La Jolla Shores Planned District Advisory Board (LJSPDAB) APPLICANT PROJECT INFORMATION FORM

- Project Tracking System (PTS) Number/Accela "PRJ" Number and Project Name (only submitted projects to the Development Services Department can be heard as action items):
PRJ-1085883

- Address and APN(s):
8303 LA JOLLA SHORES DRIVE, LA JOLLA, CA 92037
APN(s): 346-250-0800, 346-250-0900, 346-250-1000
- Project contact name, phone, e-mail:
ANDY FOTSCH - WILL AND FOTSCH ARCHITECTS
858-224-2486
PERMITS@WILLANDFOTSCH.COM

- Project description:
 - **SITE DEVELOPMENT/COASTAL DEVELOPMENT/NEIGHBORHOOD DEVELOPMENT PLANS**
 - 1 CONSOLIDATED LOT SPLIT INTO 6 INDIVIDUAL LOTS
 - EACH LOT TO CONSIST OF 1 SINGLE FAMILY DWELLING

TREE DEMO -
PROTECTION
PLAN

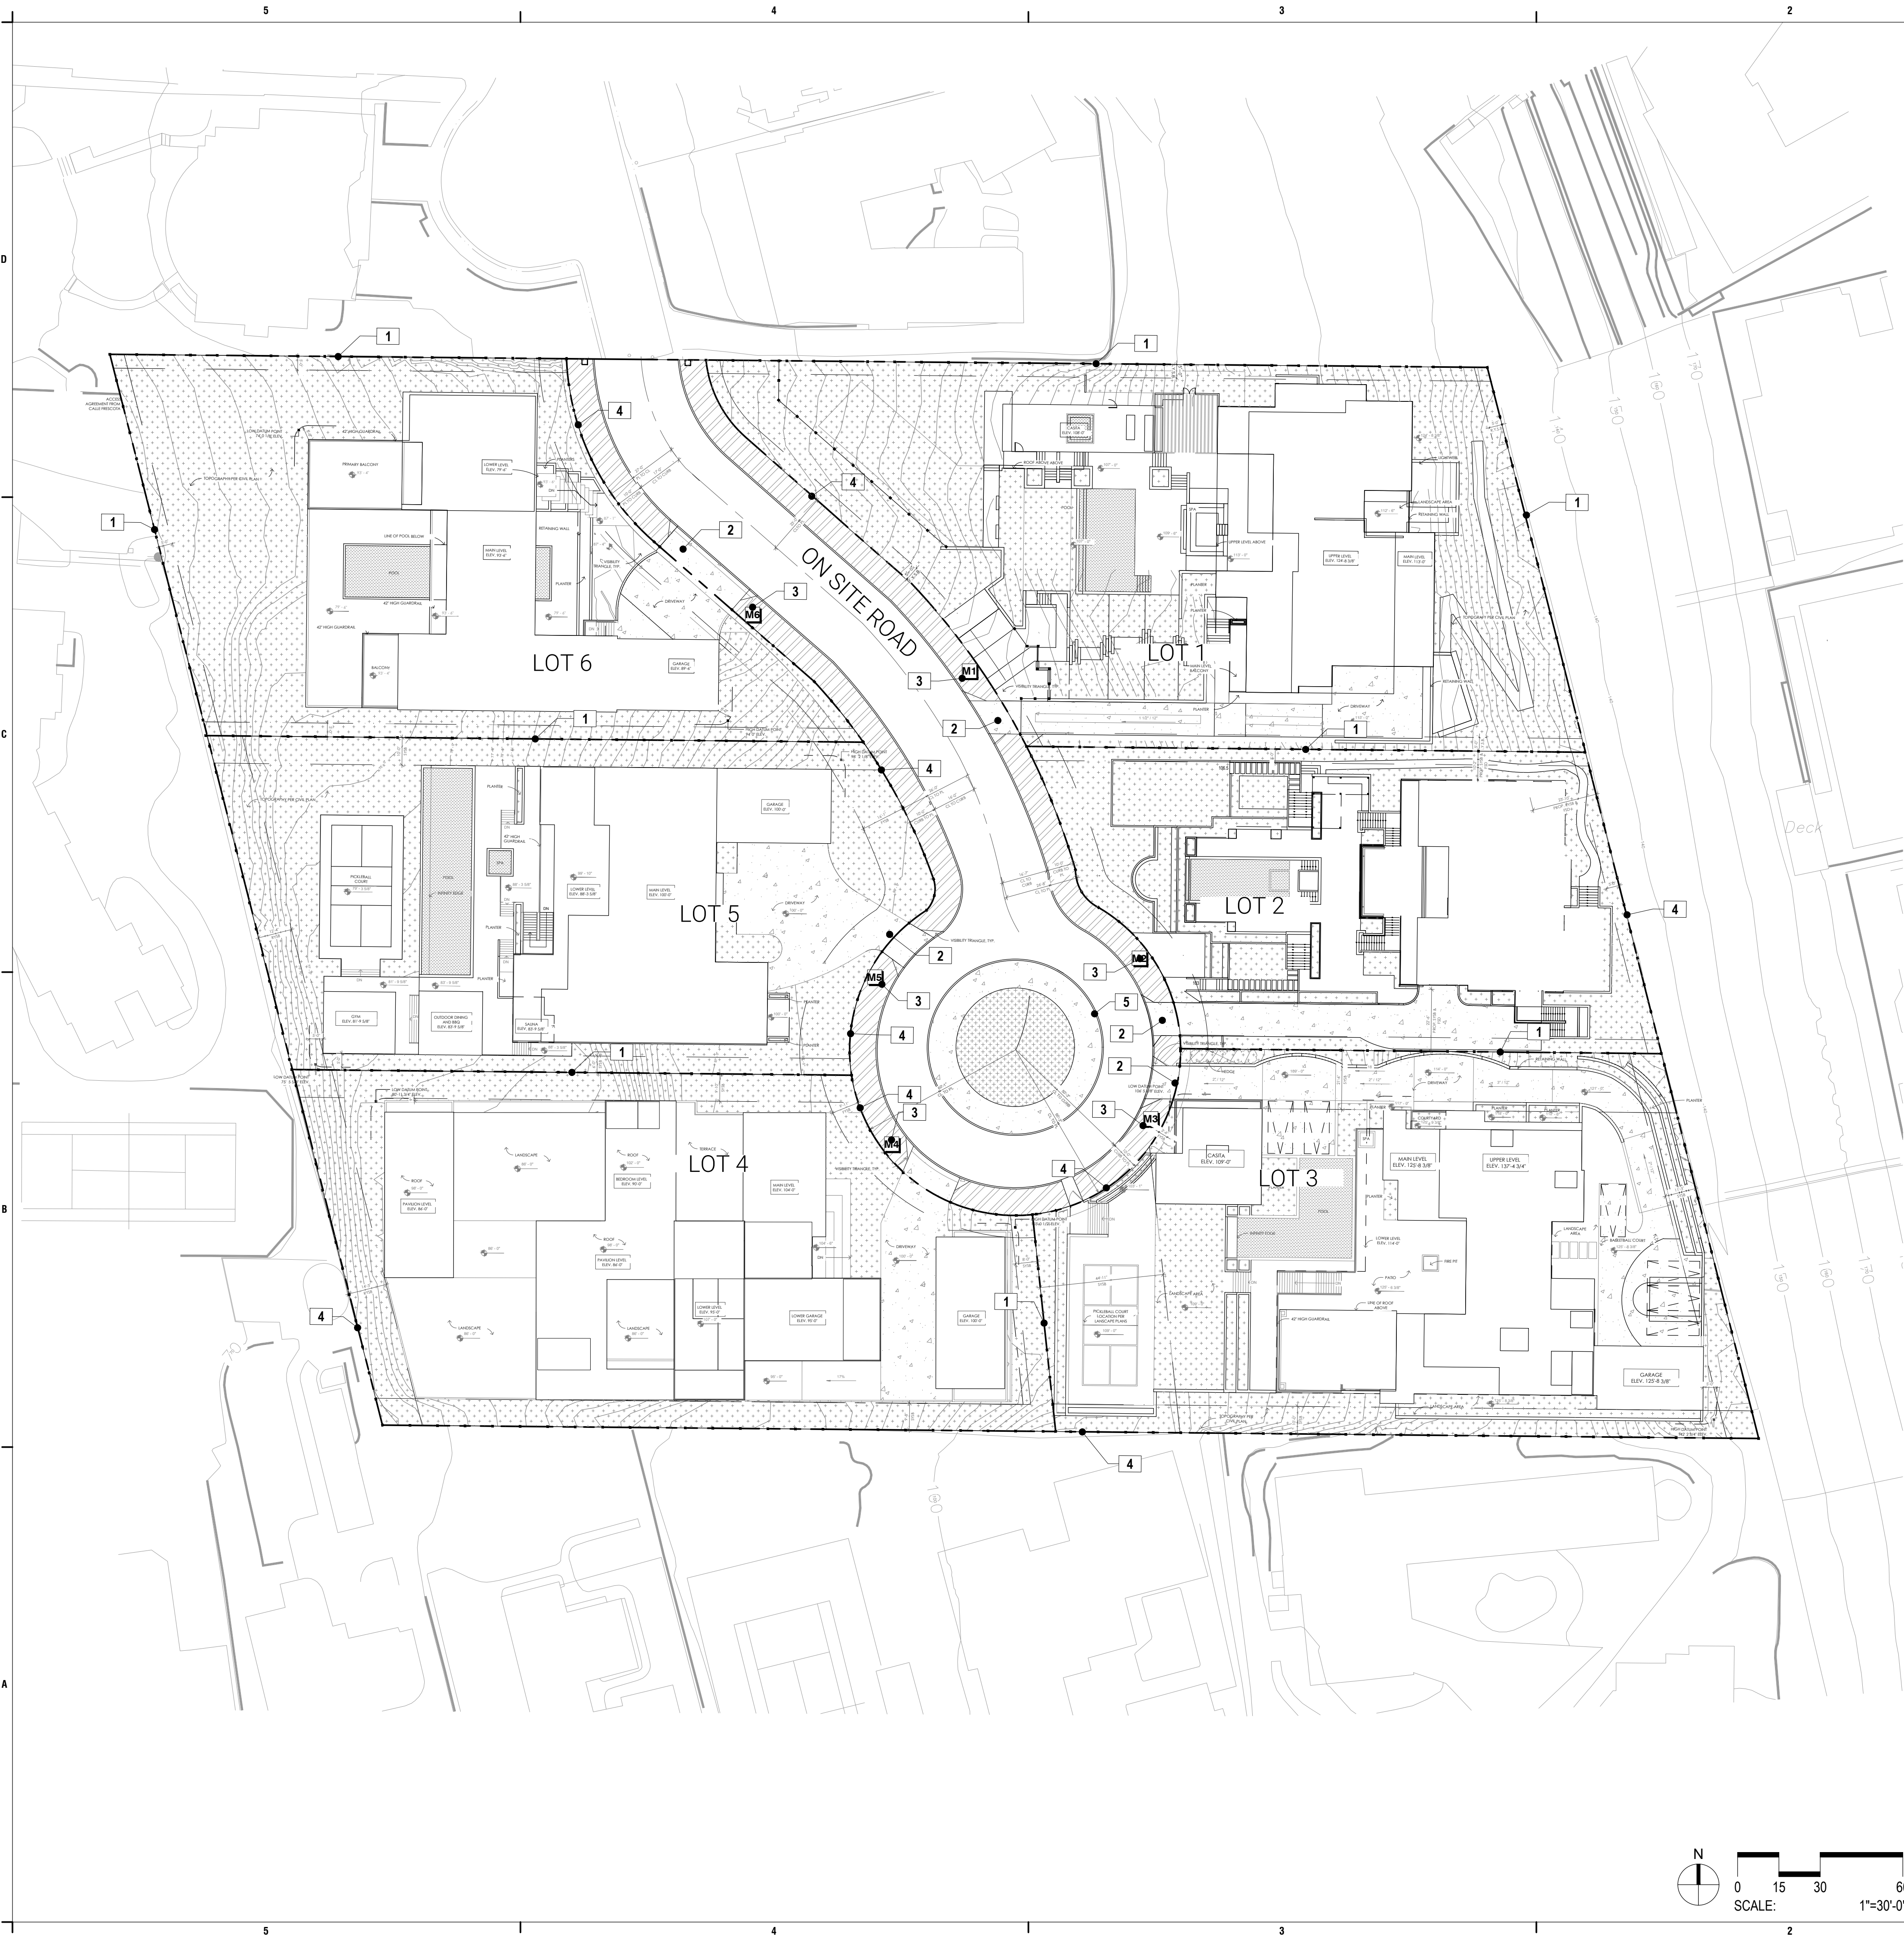
In addition, Sheets L000, L010, L100, L200, and L300 show 6 surface parking spaces, whereas Sheets A000 and A003 show 1 surface parking space. Please correct these discrepancies and revise the plans per the comments above.

M-1

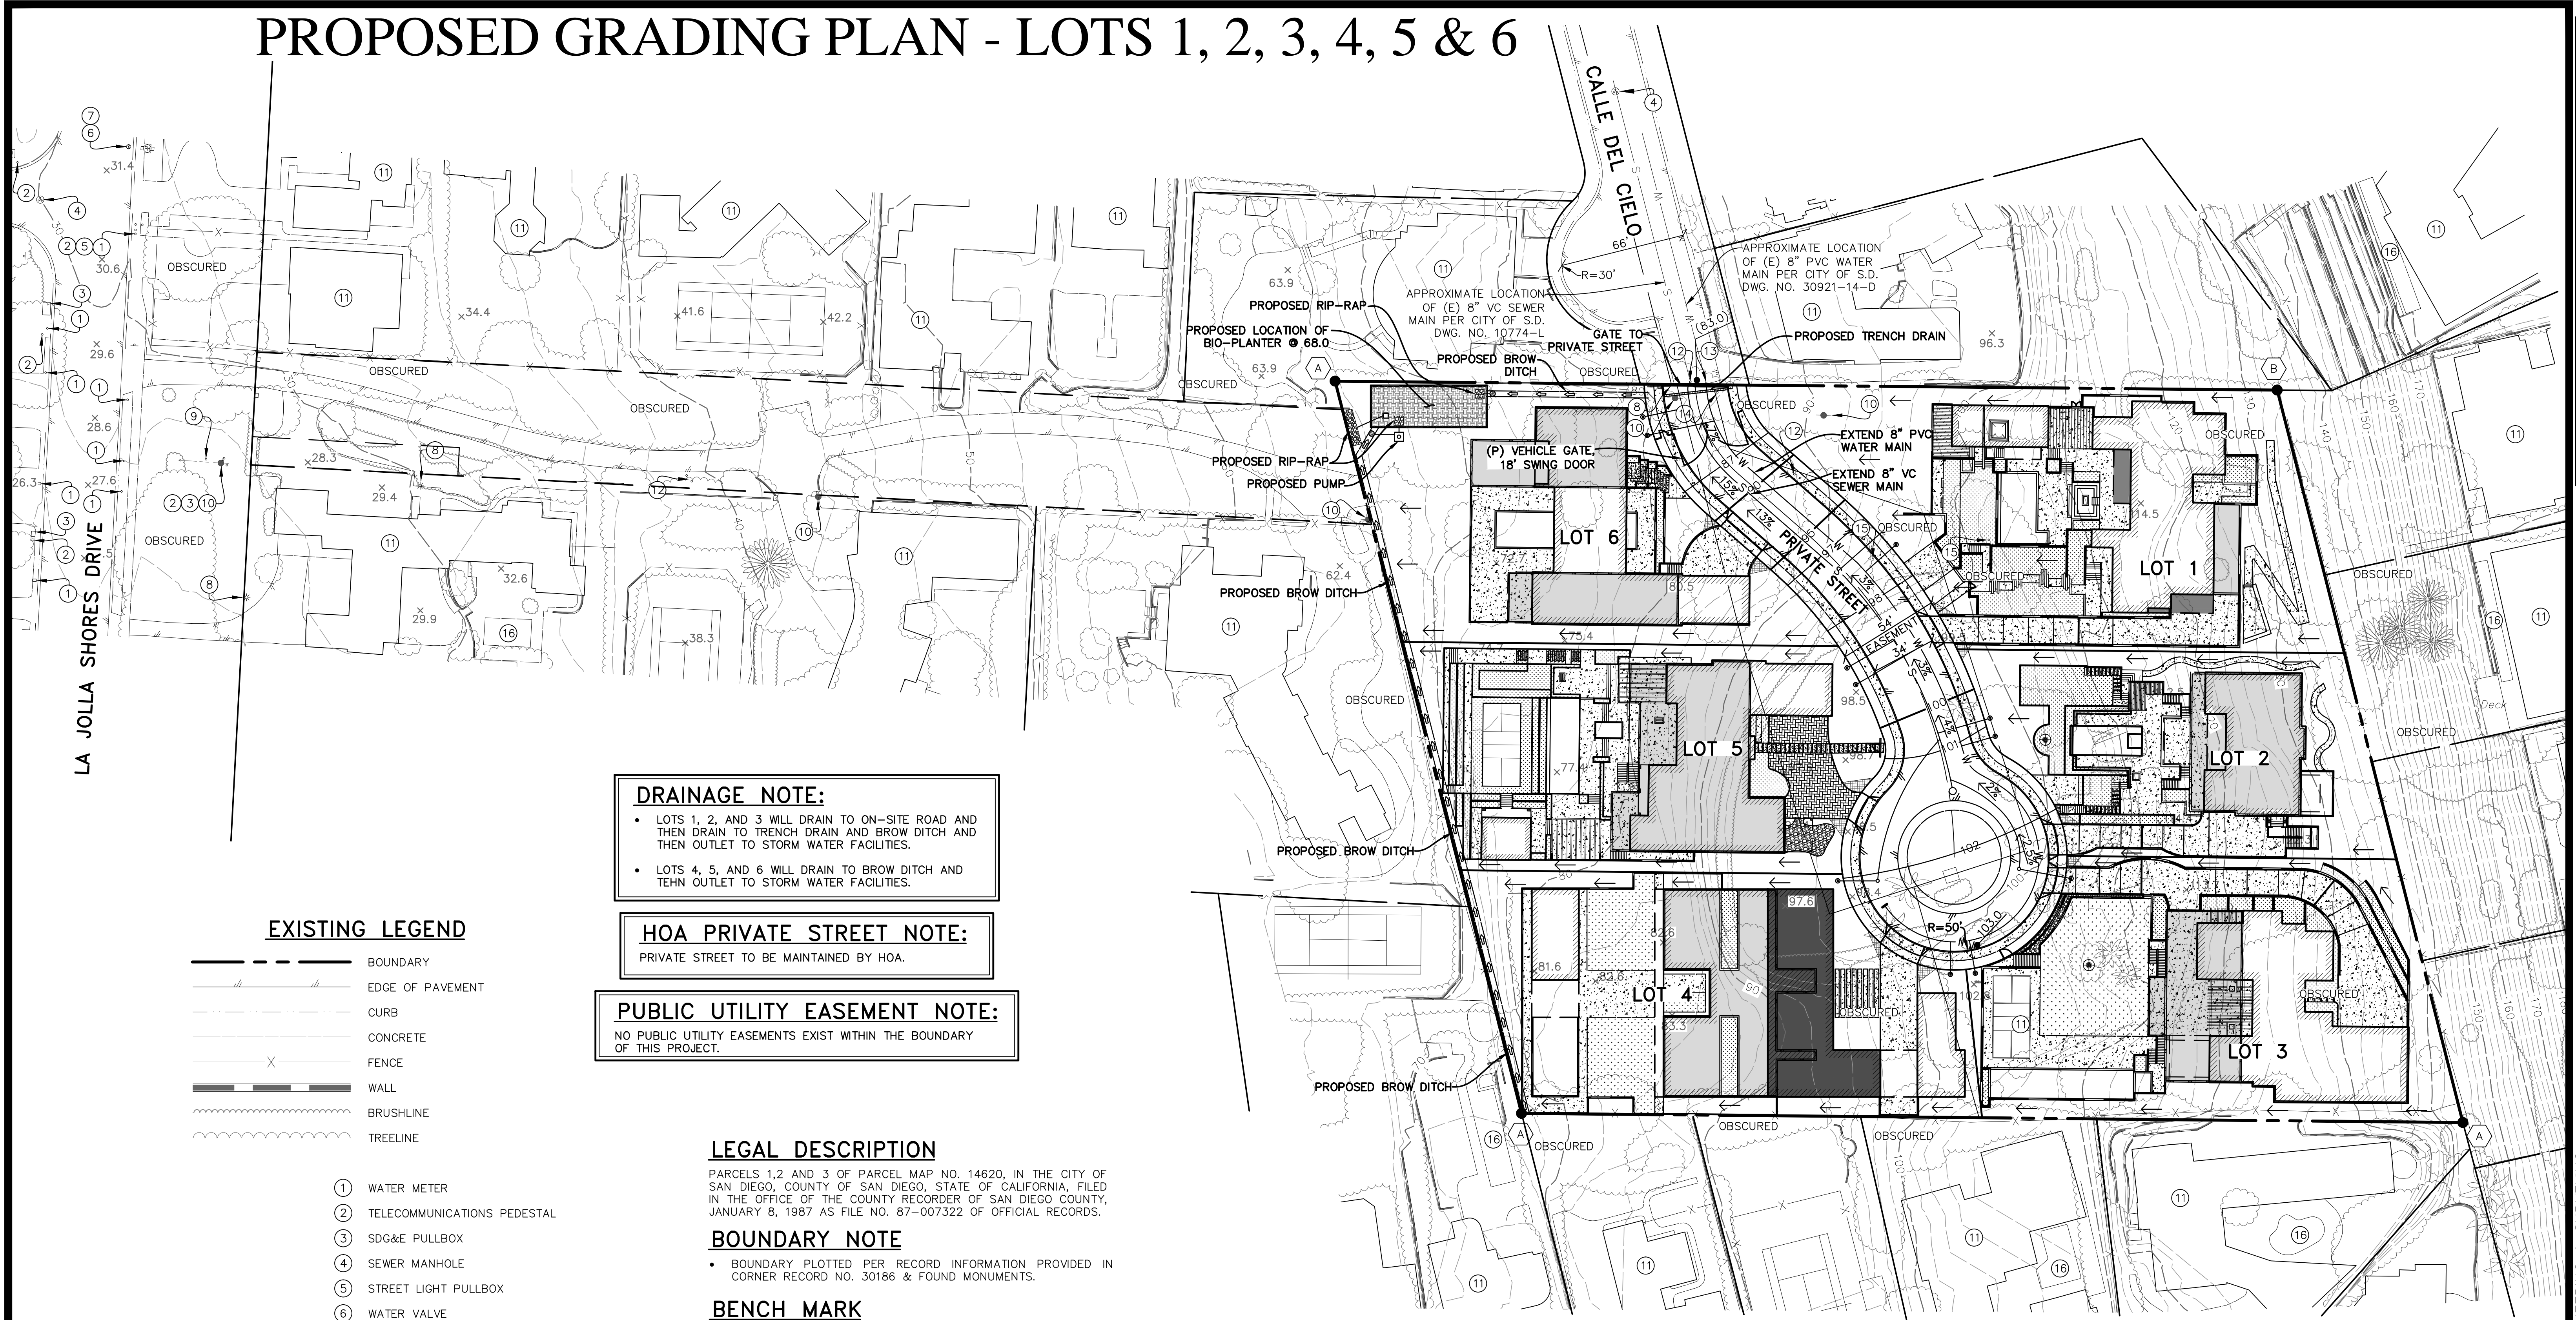
Per Issue #92 in the previous review cycle, cross sections for the proposed private street is provided in Sheet M-1; please also provide full roadway cross sections of Calle Del Cielo including right-of-way to right-of-way line, centerline to property line distance, centerline to curb line distance, curb to property line distance, radius of cul-de-sac bulb, and location and width of sidewalk. (2nd Request)

Per Issue #99 in the previous review cycle, Sheet M-1 shows the proposed gate at the entrance of the private street; please demonstrate how the proposed private street will connect and transition with Calle Del Cielo including sidewalk transition. Please show existing improvements along the cul-de-sac bulb of Calle Del Cielo including the existing sidewalk. Please also show the existing curb cut along the cul-de-sac to show whether the proposed project improvements would affect the neighboring lots and clearly dimension the street frontage in feet along Calle Del Cielo.

Per applicant's response to Issue #108, cross-section on Sheet M-1 shows a curb-to-curb width of 34 feet. Please clarify and show and dimension on the plans and private street cross-section whether on-street parking is proposed along the proposed private street. (2nd Request)

Per response to Issues #108 and #207, applicant states that parking will be allowed on both sides of the proposed private street. Please revise plans and private street cross-section on Sheet M-1 to show the parking lane with dimensions. (3rd Request)

C-1
LOTS 1-6

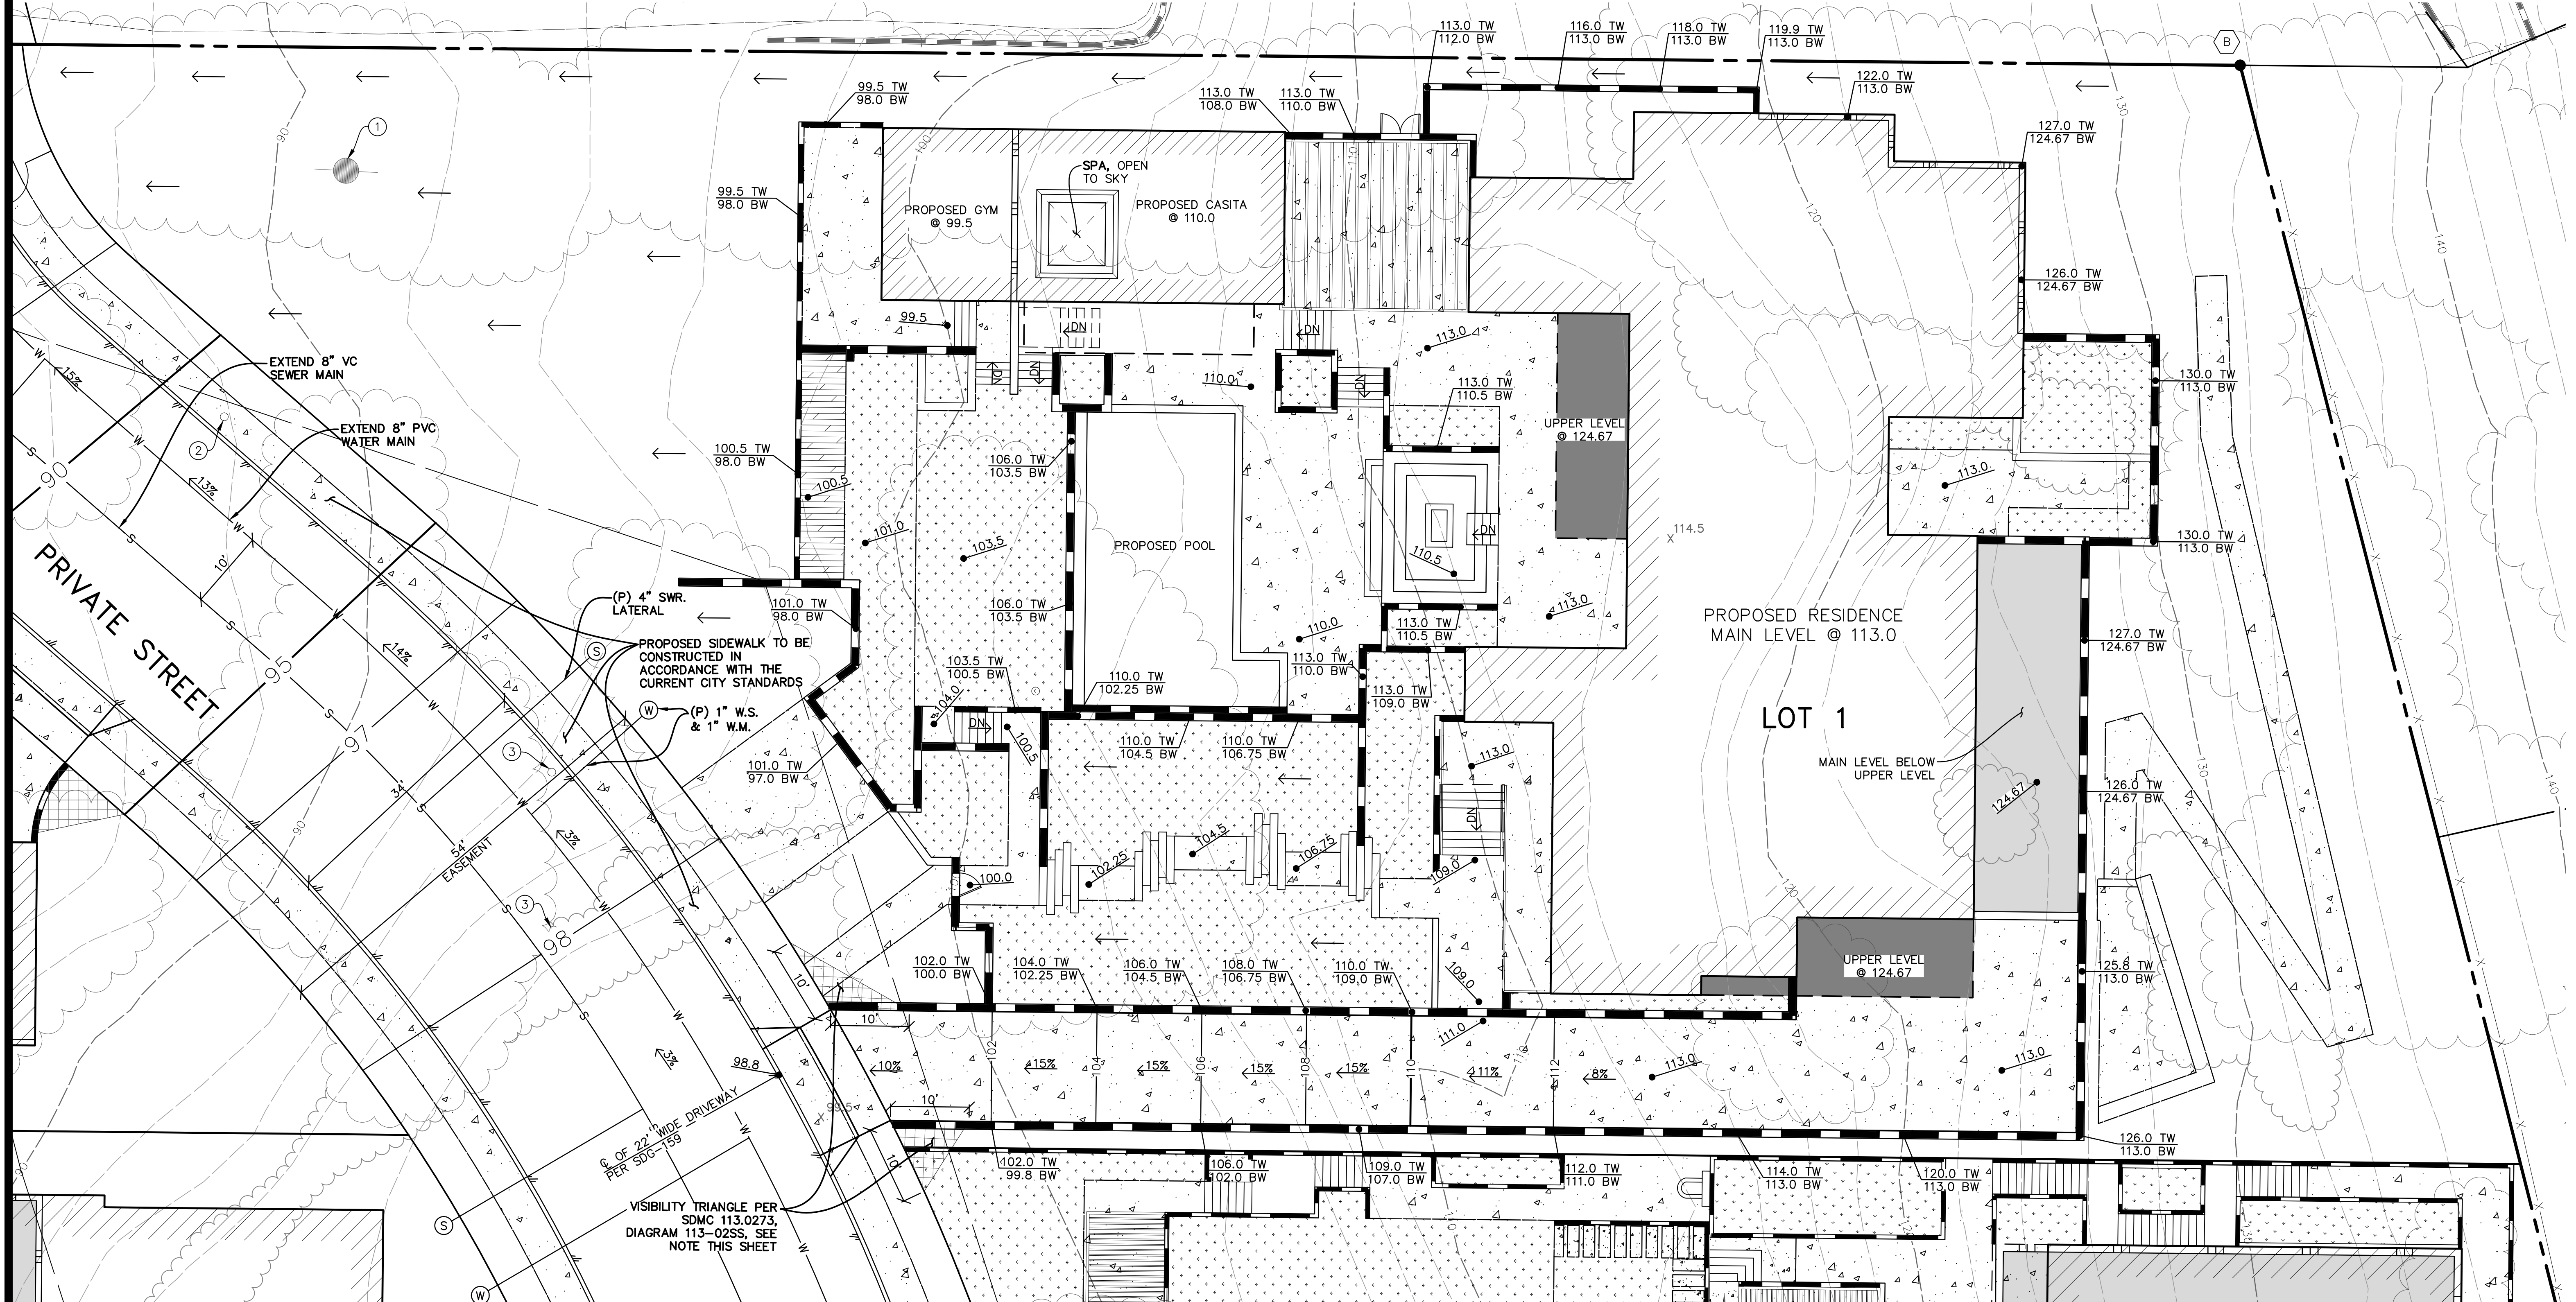
In addition, Sheet M-1 labels the location of the gate at the property line, whereas Sheets C-1, C-7, A000, and A601 show the gate further into the project site. Please revise and correct this discrepancy.
